DESIGN BRIEF

**Development Review, Central
Planning, Infrastructure and Economic
Development Department
City of Ottawa**

**1806 Scott Street, Ottawa
16-unit Low-Rise Apartment Building**

November 23, 2022

2 GARBAGE ROOM PART PLAN
 A000 1:50

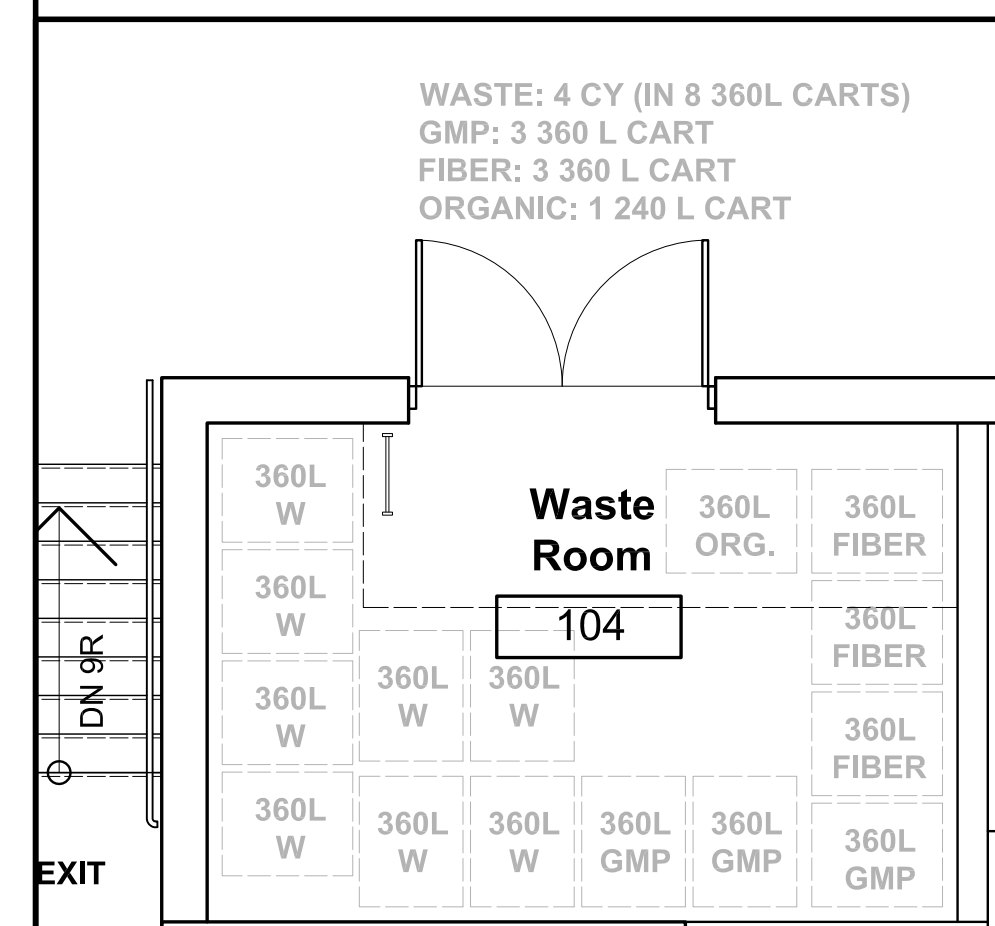
Garbage/bike storage: *In a context as sensitive as this we recommend the storage of garbage and bikes be internal to the building envelope;*

Response: Waste and bicycle storage rooms have been reintegrated into the interior of the building and are positioned at grade level to make circulation most effective.

1 LANDSCAPE PLAN

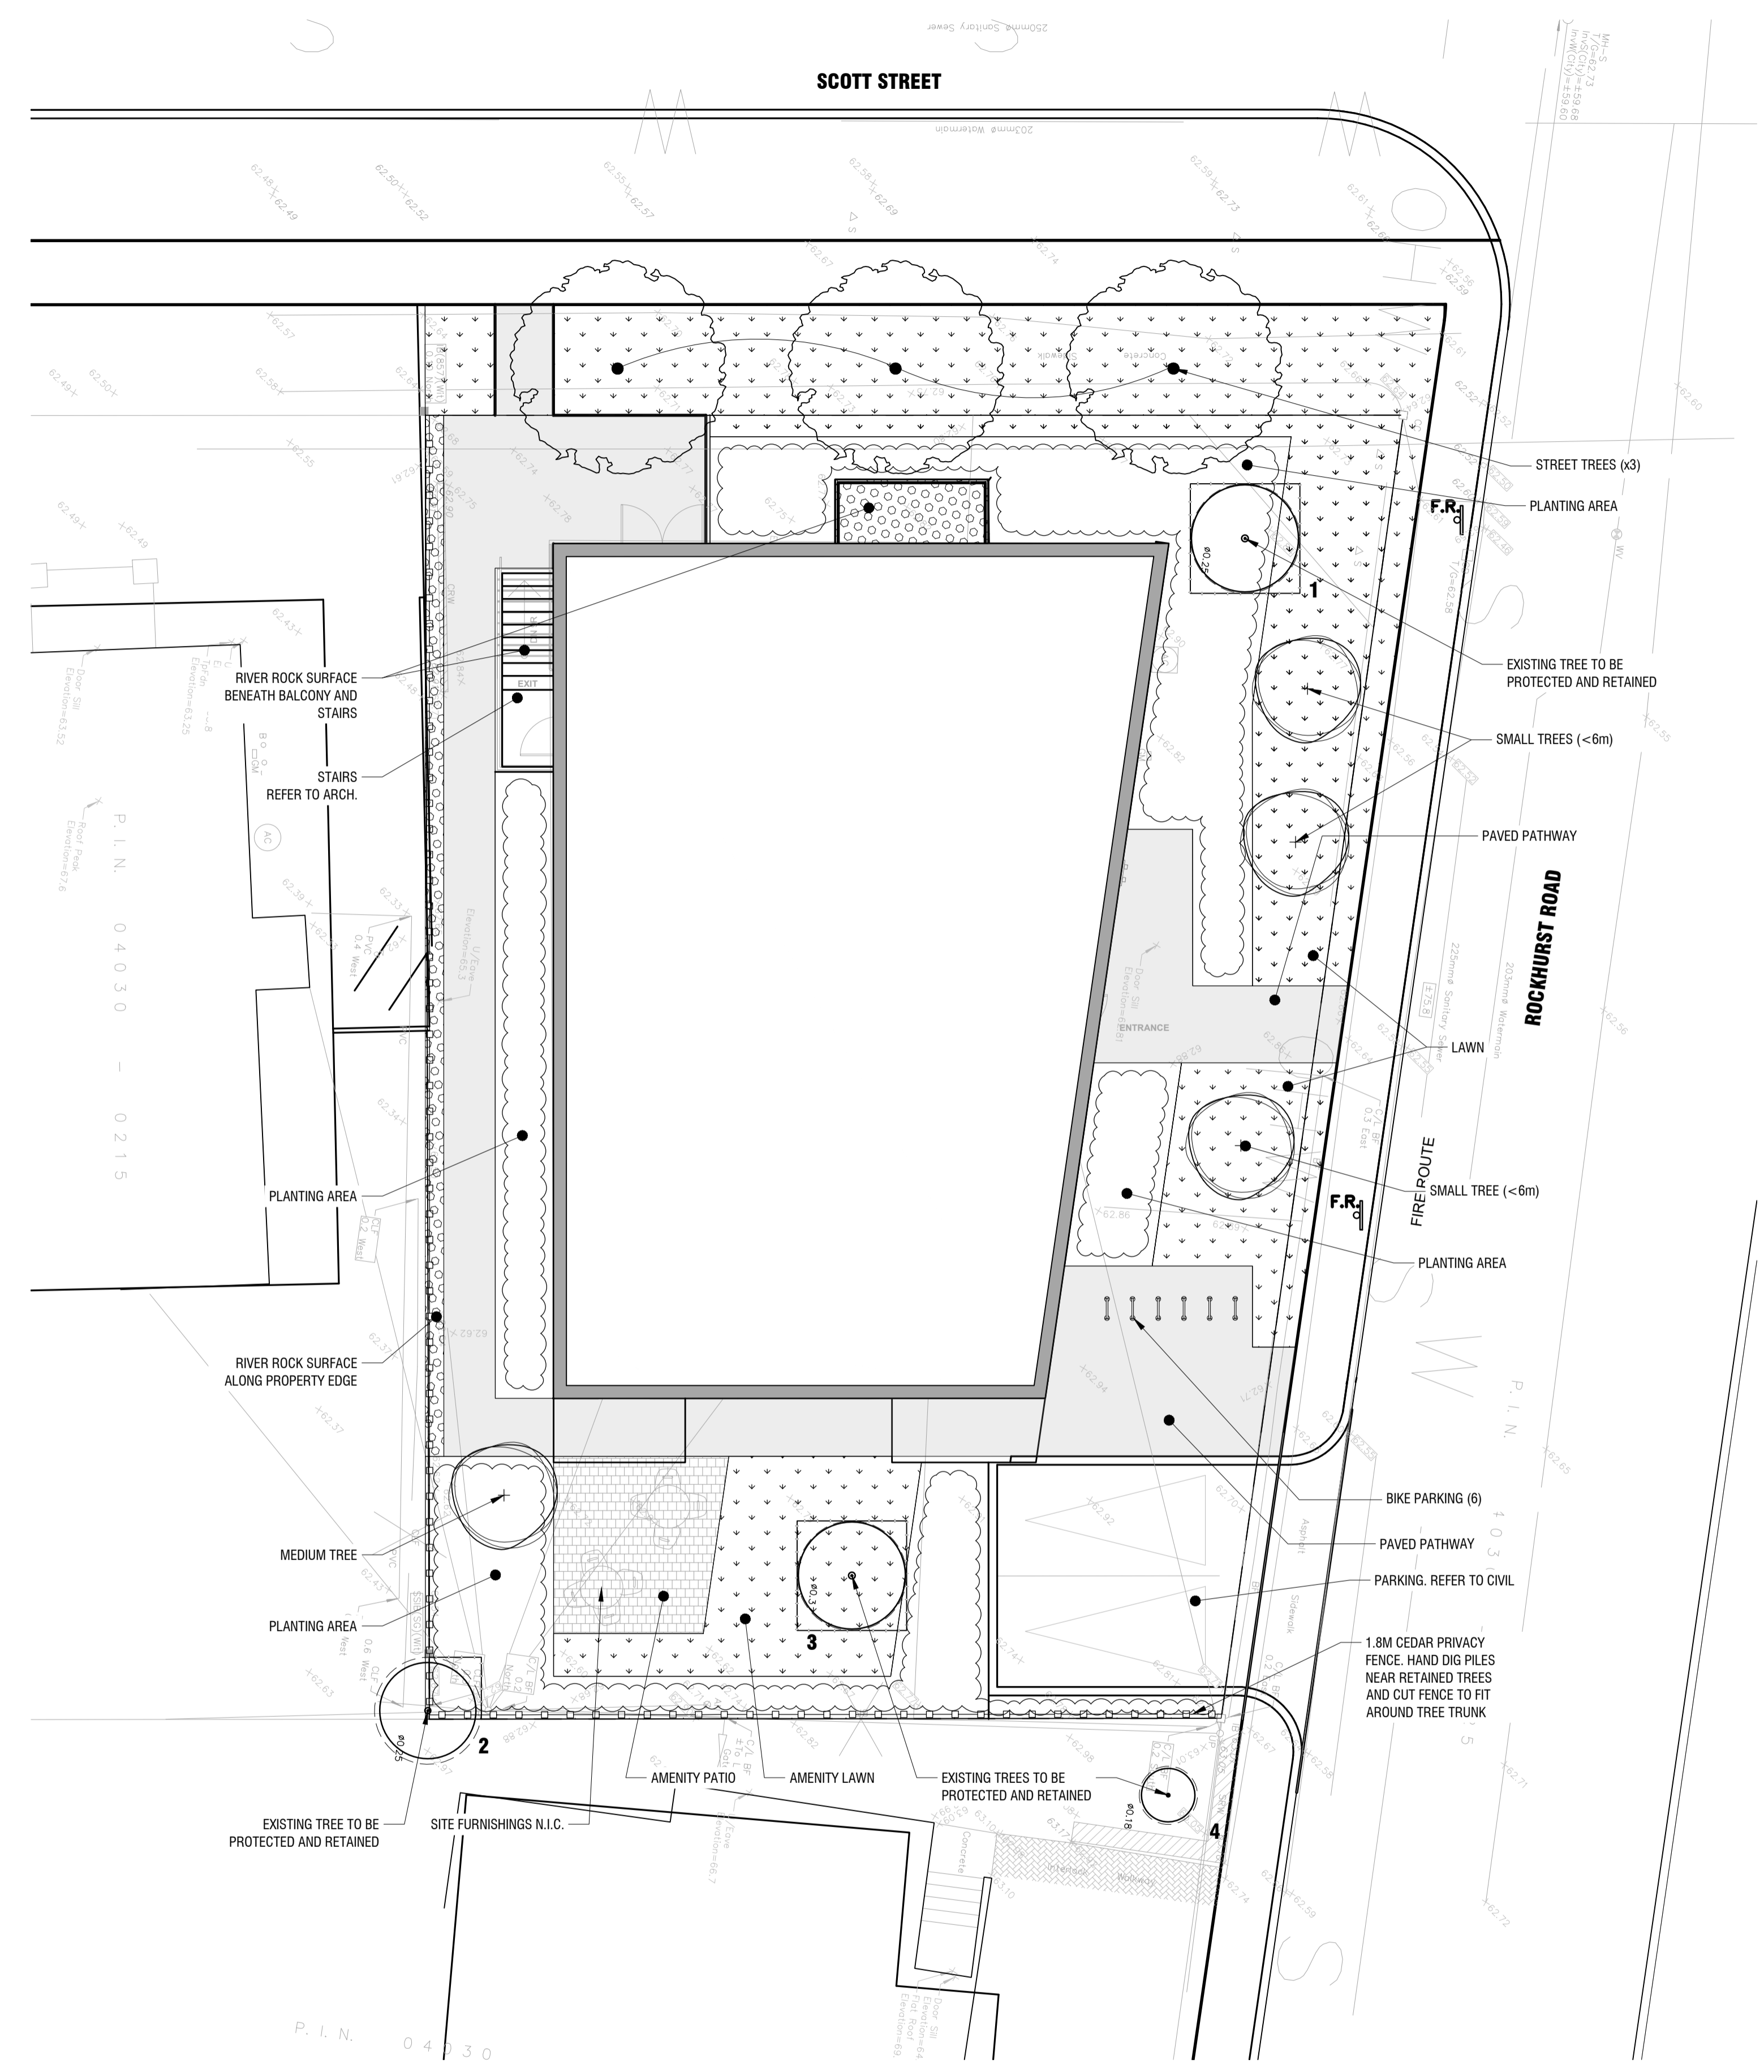
Trees: *We recommend efforts be made to preserve existing trees and for the Site Plan to indicate these and provide locations for new trees on the site.*

Response: 3 existing trees will be preserved (please refer to landscape plan) and the proposal includes a plan to add 7 additional trees. These will be located along Scott Street (3 new trees), at Rockhurst (3 small deciduous trees) and in the interior side yard (1 small deciduous tree).
